**City of Sedona Community Development Department  
Engineering Services**

The City of Sedona, Arizona is issuing **Addendum # 1** to the plans and specifications as originally issued at the time of solicitation for bids for the **WWRP A+ Upgrades Project**. For any bid to be considered responsible and responsive, receipt of this addendum must be acknowledged.

*This Addendum changes the following:*

**A631**  
TYP

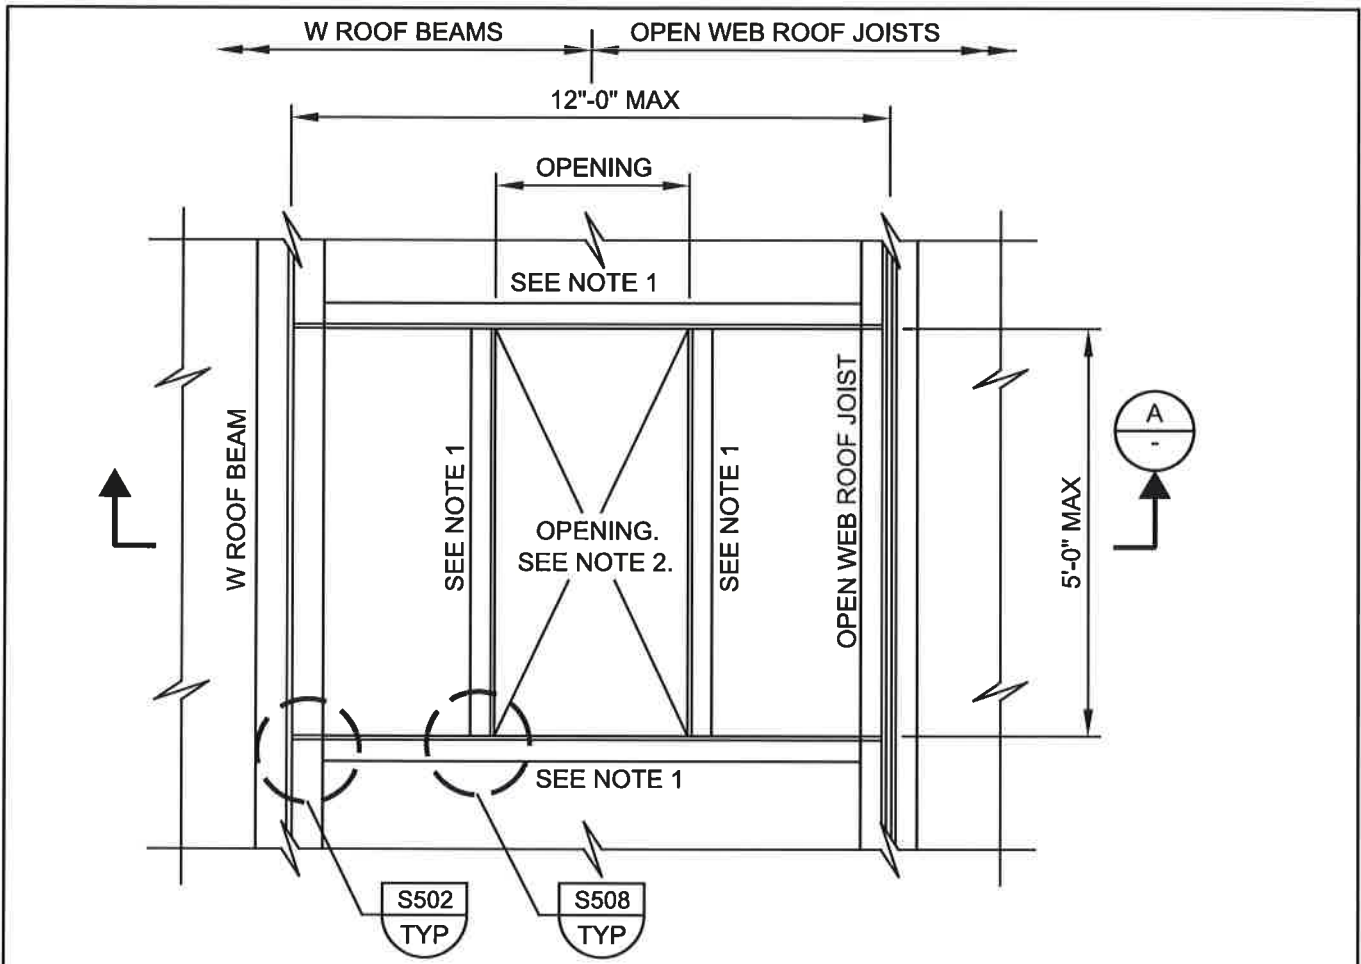
- a. Surface prep: sand blast to expose aggregate (80 grit)
  - b. Apply in two (2) coats, 125 mil thickness total.
5. **Drawing 70-S-01:** Add note to Roof Plan "A" as follows: Construct roof opening for relief hood per Typical details A631 and S520 (attached)
